Product Change Notification / GBNG-16BGIH897

CCB 4628 and 4628.001 Final Notice: Qualification of STA as an additional assembly site for selected LAN9500A, USB2512B, USB2513B, USB2514B and USX2064 device families available in 56L VQFN (8x8x0.9mm) and 36L VQFN (6x6x1.0mm) packages.

CCB 4628 and 4628.001
Pre and Post Change Summary
PCN #: GBNG-16BGIH897

56L VQFN

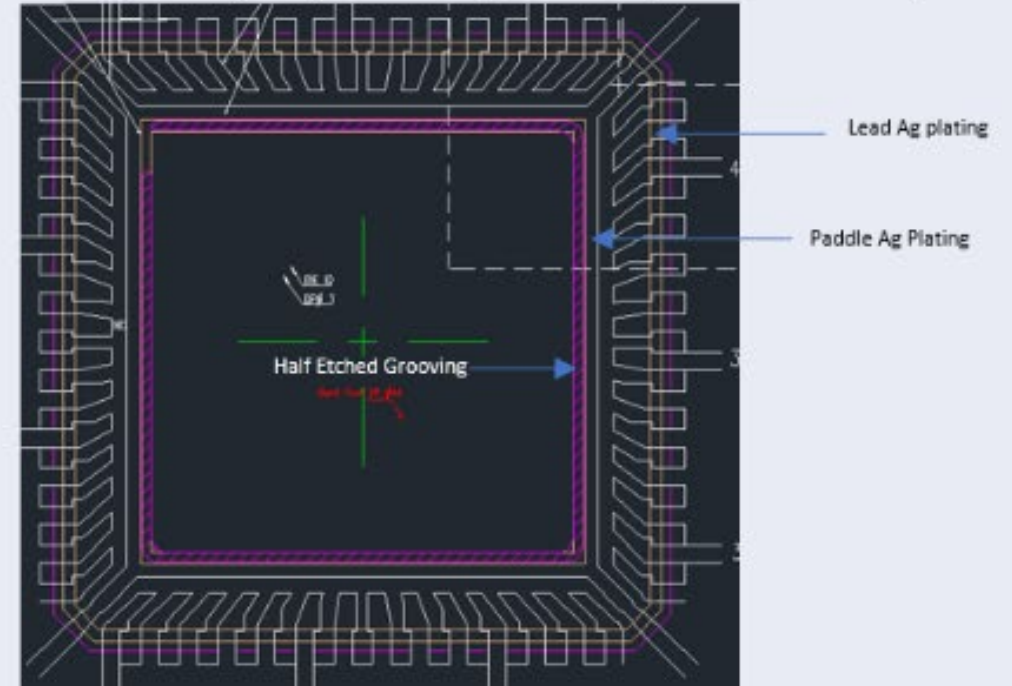
Lead frame Comparison

ASE

LF Definition – Double Ring Plating

*Plating on Lead finger and plating surrounding LF Paddle (Purple shaded area)

STA

LF Definition – Double Ring Plating

*Plating on Lead finger and plating surrounding LF Paddle (Yellow outline area)

36L VQFN

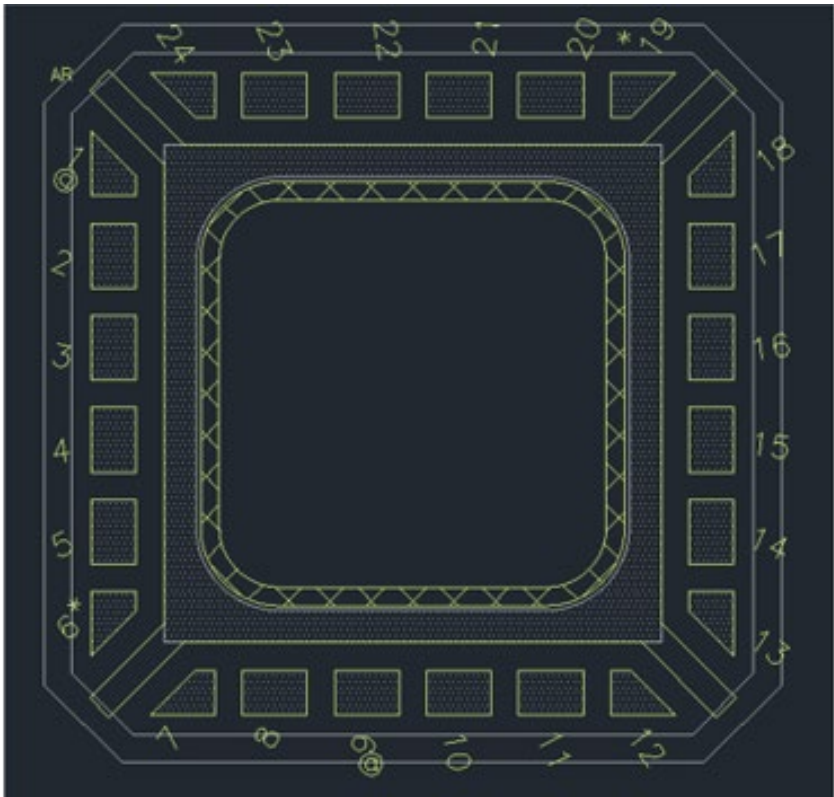
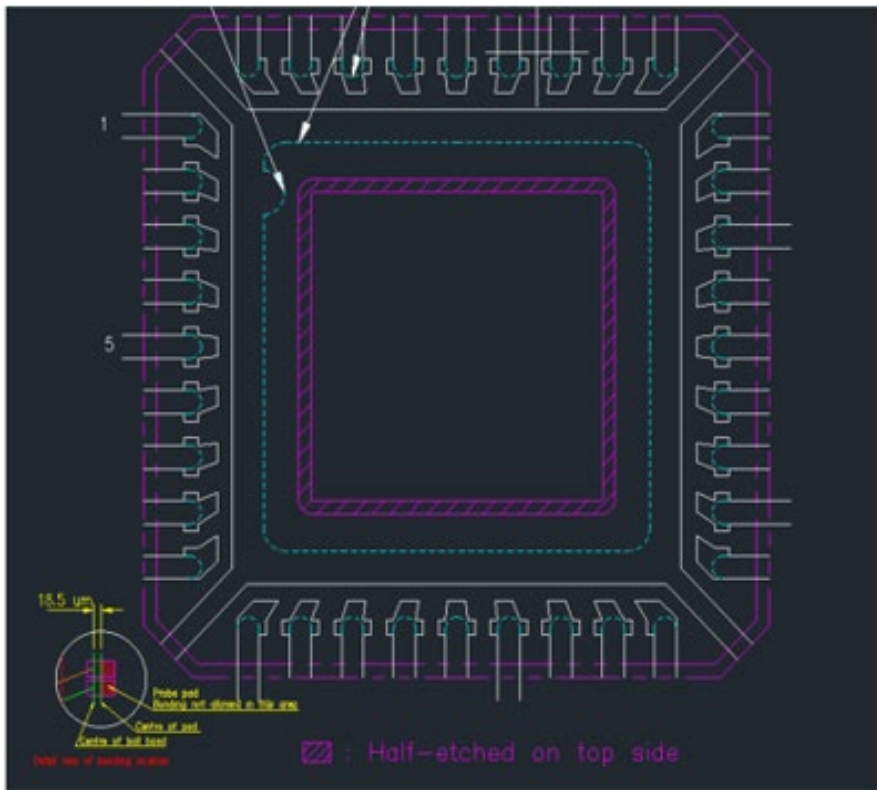
Lead frame Comparison

ASE

STA
